ADDENDUM No. 03
DNR-220039
Delaware State Park Wastewater Treatment
April 2, 2024

2. The following additional questions have been received to date:

STATE OF OHIO
DEPARTMENT OF NATURAL RESOURCES
OFFICE OF CHIEF ENGINEER
DELAWARE STATE RESERVOIR PARK
SEWAGE TREATMENT PLANT
CONCRETE SECTIONS

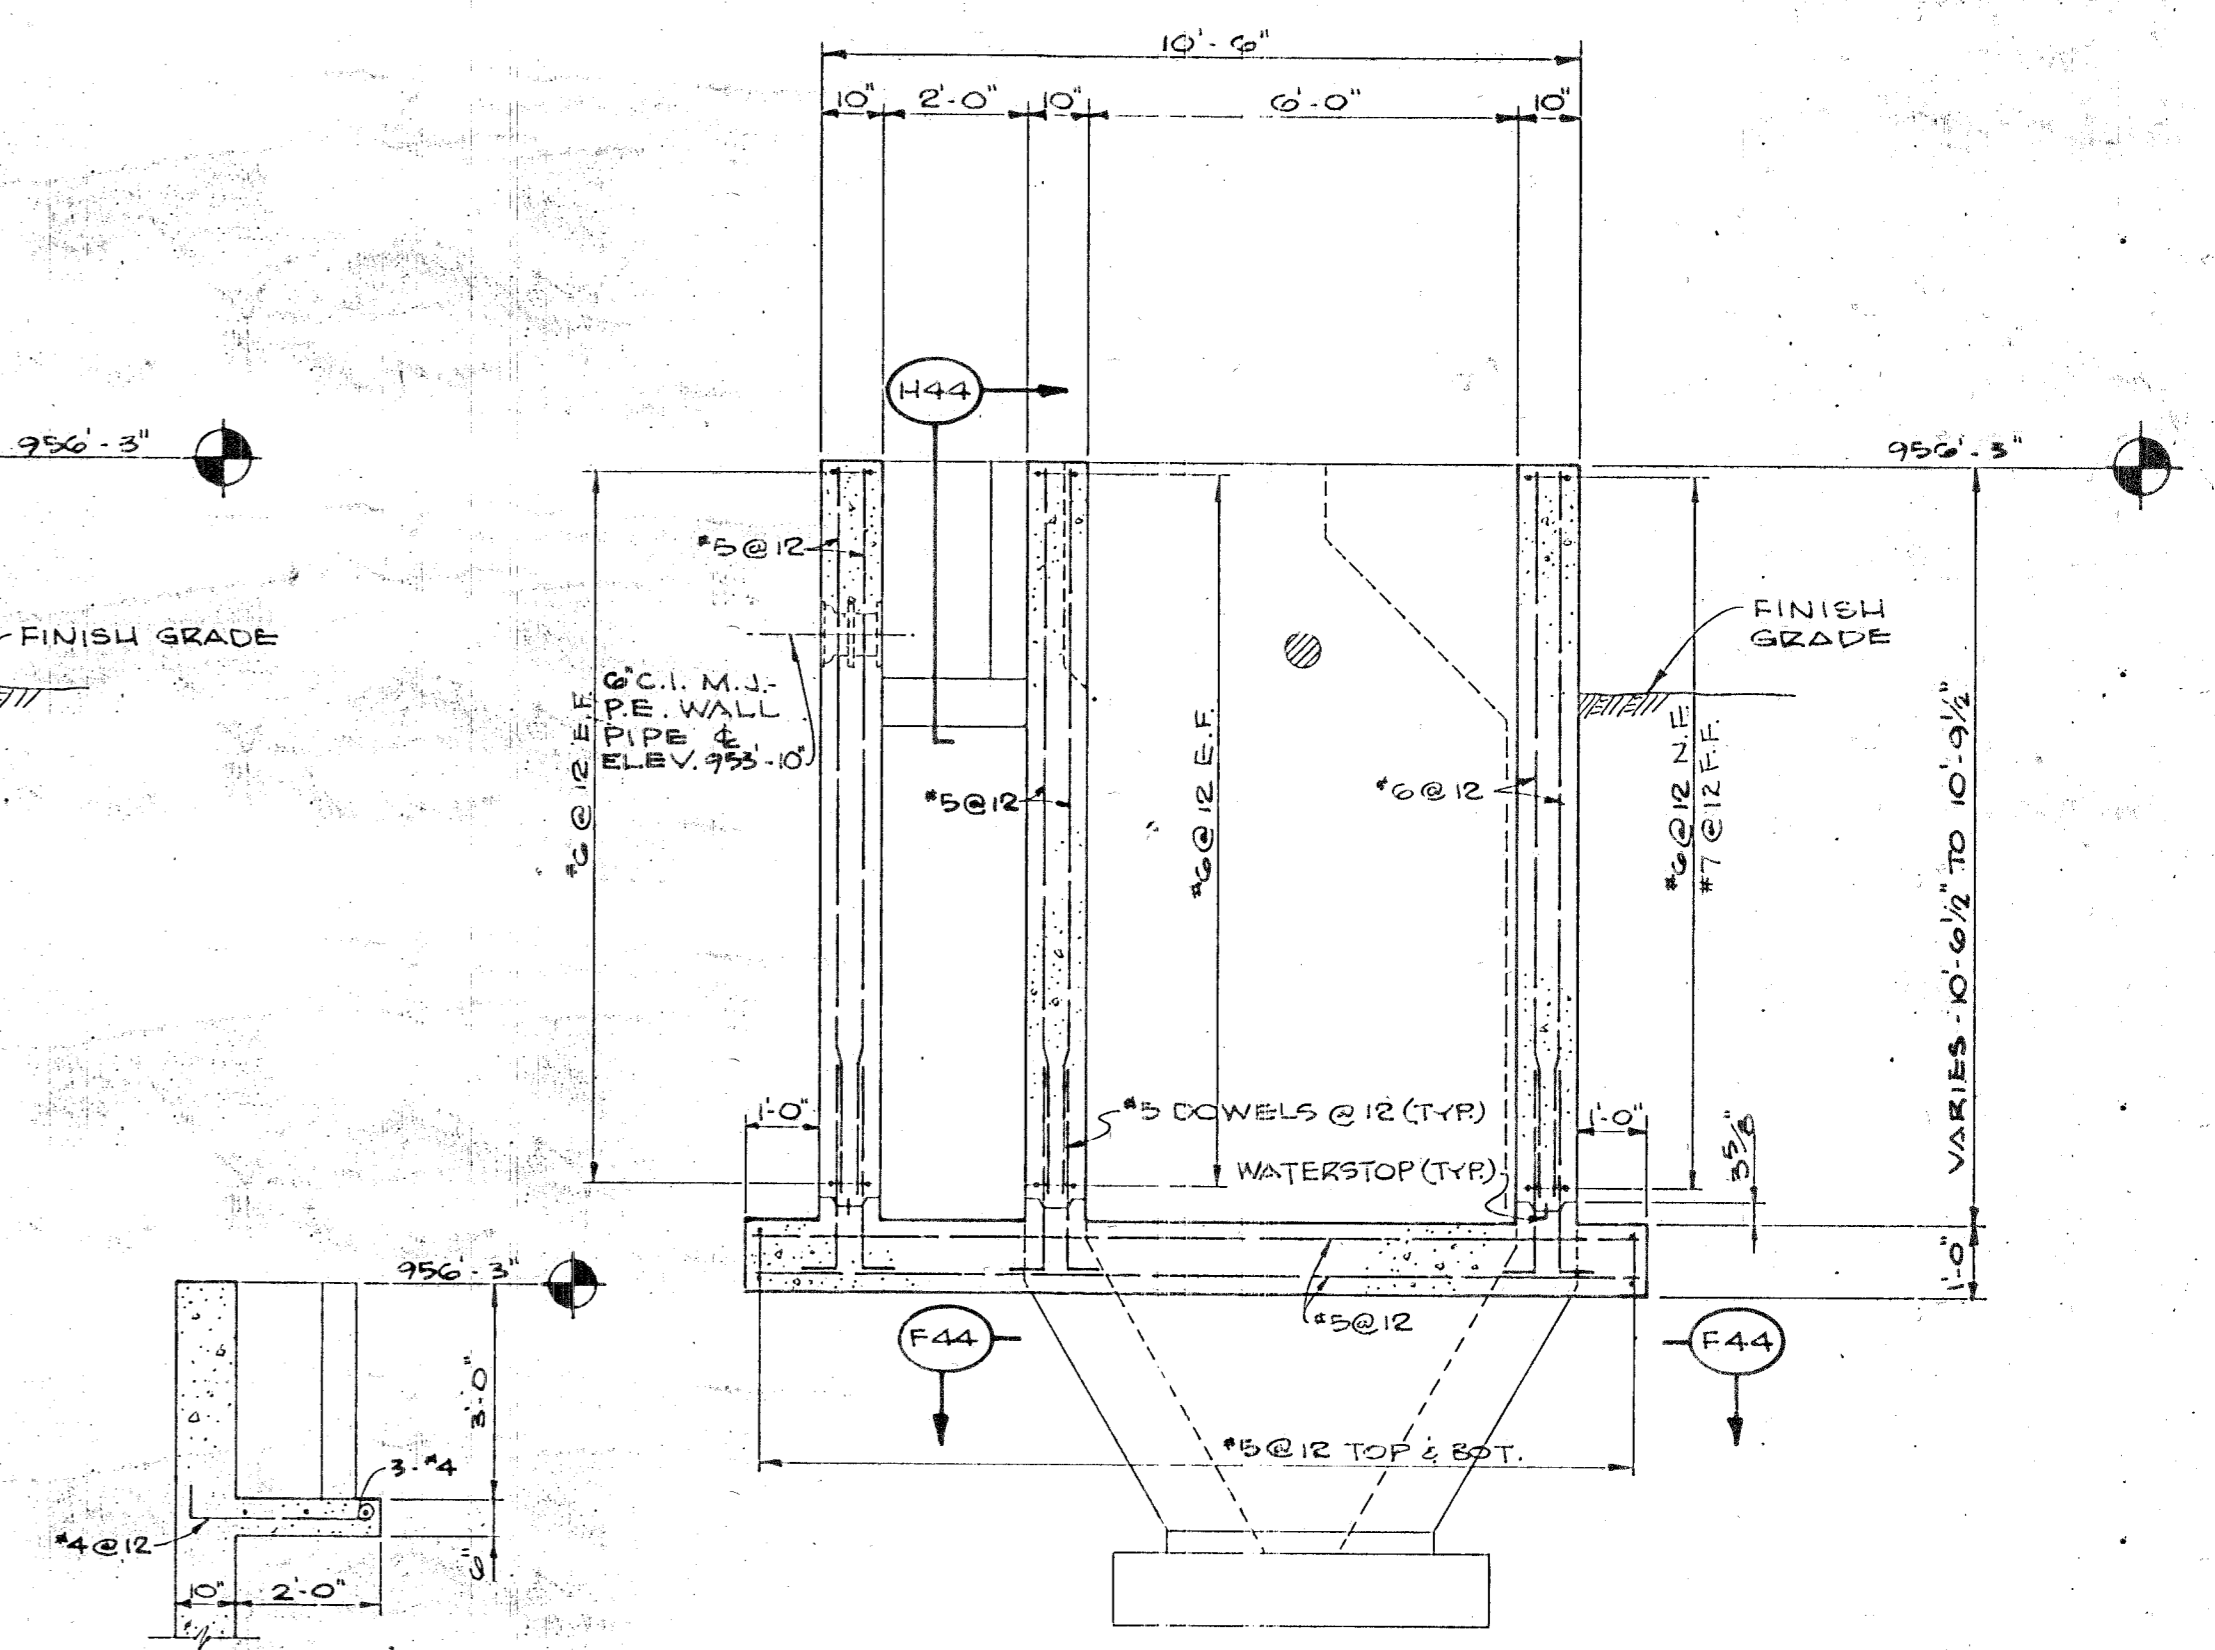
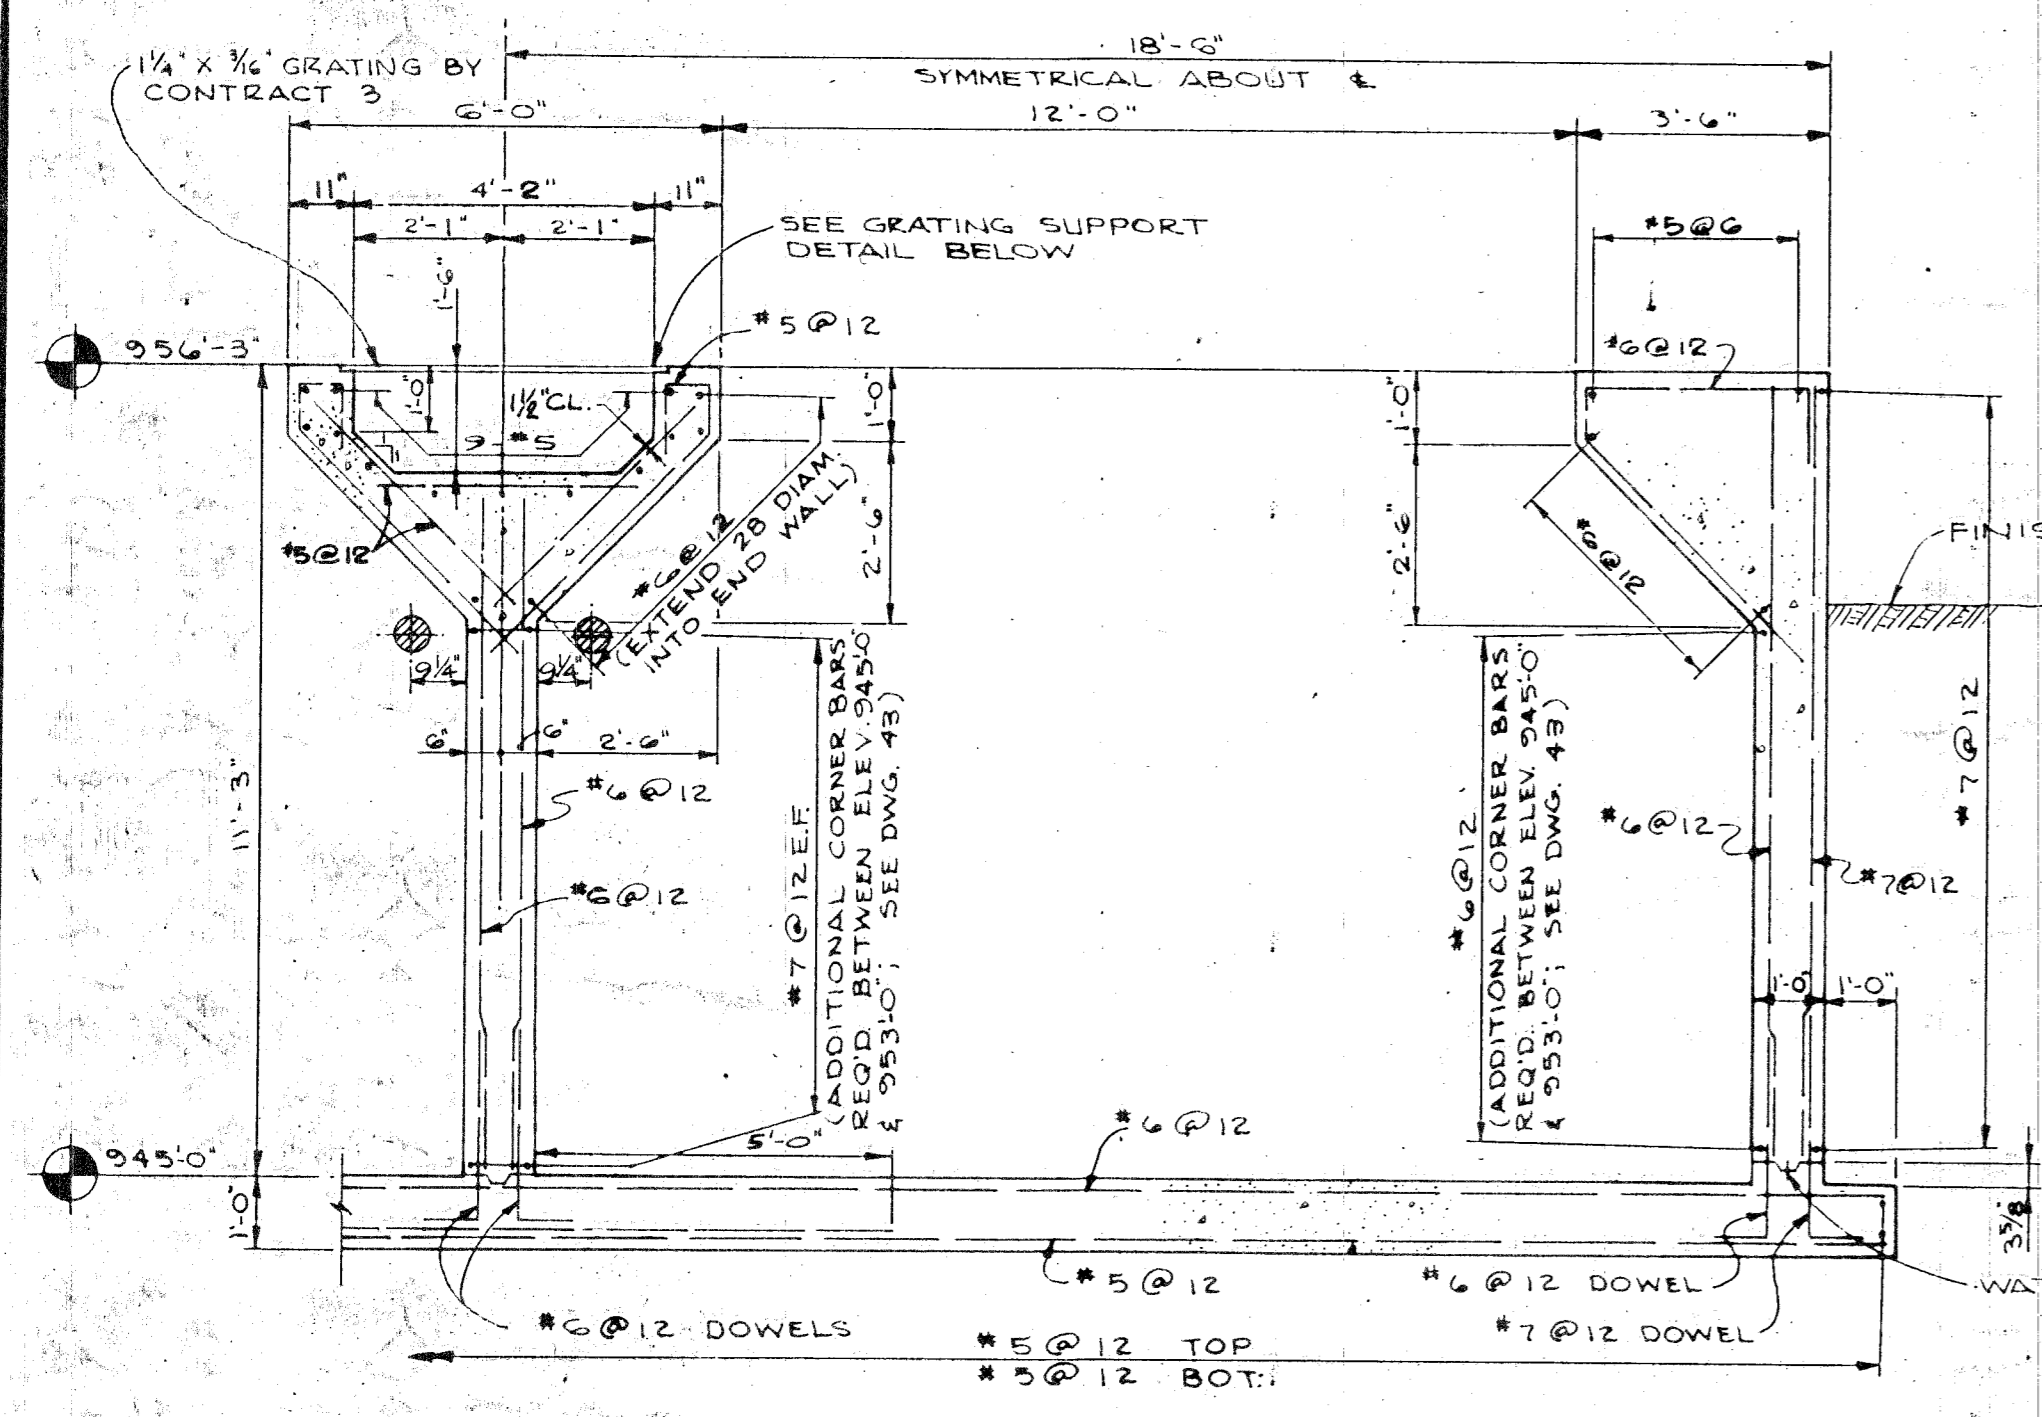
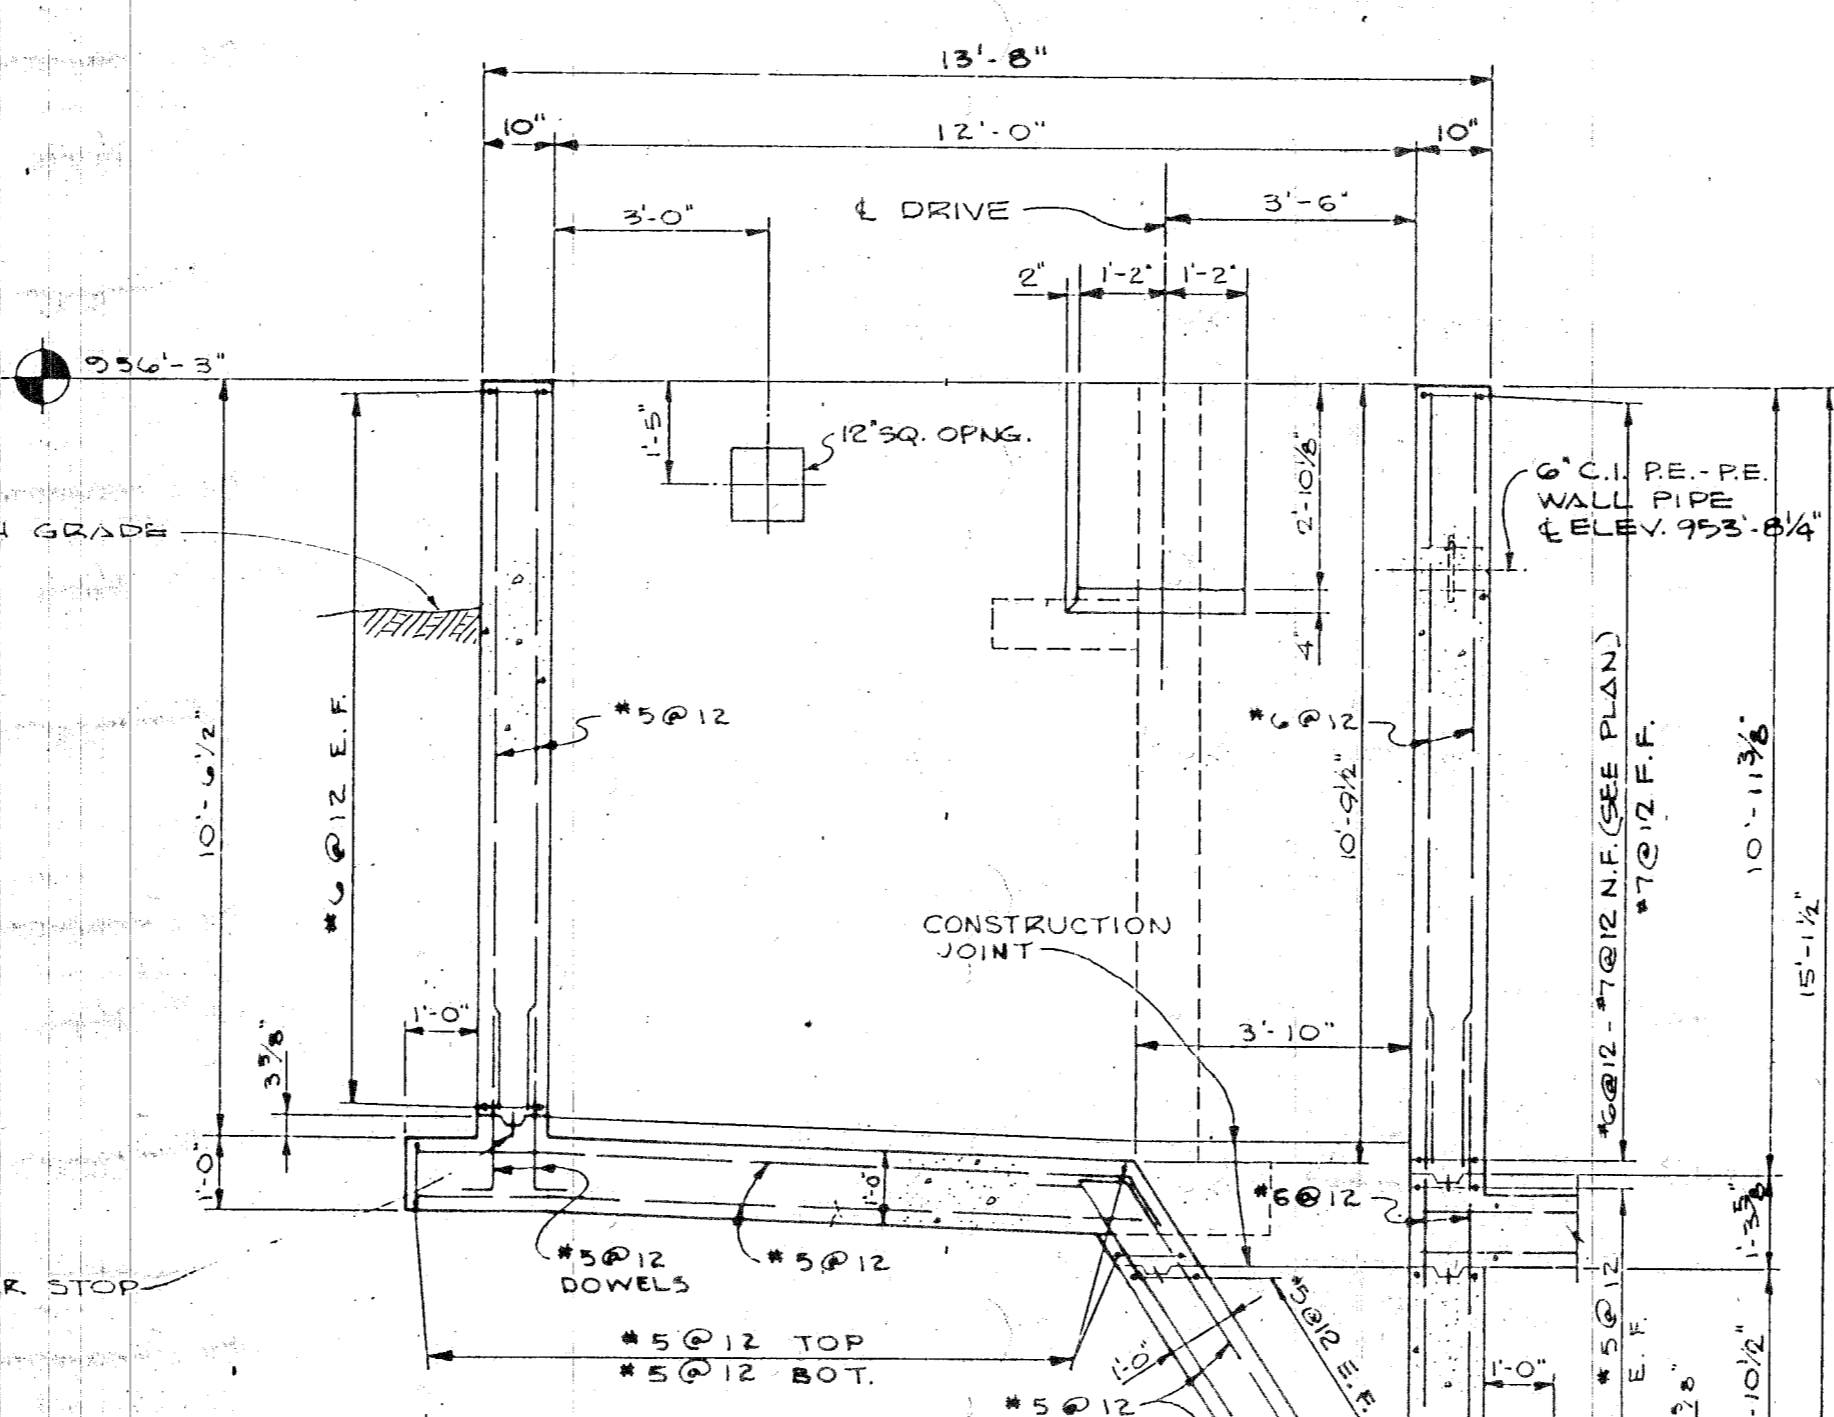
Q: Do you have the plans for the existing Plant so we can see depths and dimensions?

A: *Yes, existing plant plans that pertain are attached. Existing plant depths from top of wall to bottom of concrete (based on plans provided by ODNR); influent box (headworks) – approximately at grade; aeration tanks - approximately 12.5'; settling tank (clarifier) slopes to approximately 16.5'; chlorine contact tank – approximately 12'. The existing WWTP top of wall is approximately 2' to 3' above ground. (attached plans do not necessarily reflect as-built conditions)*
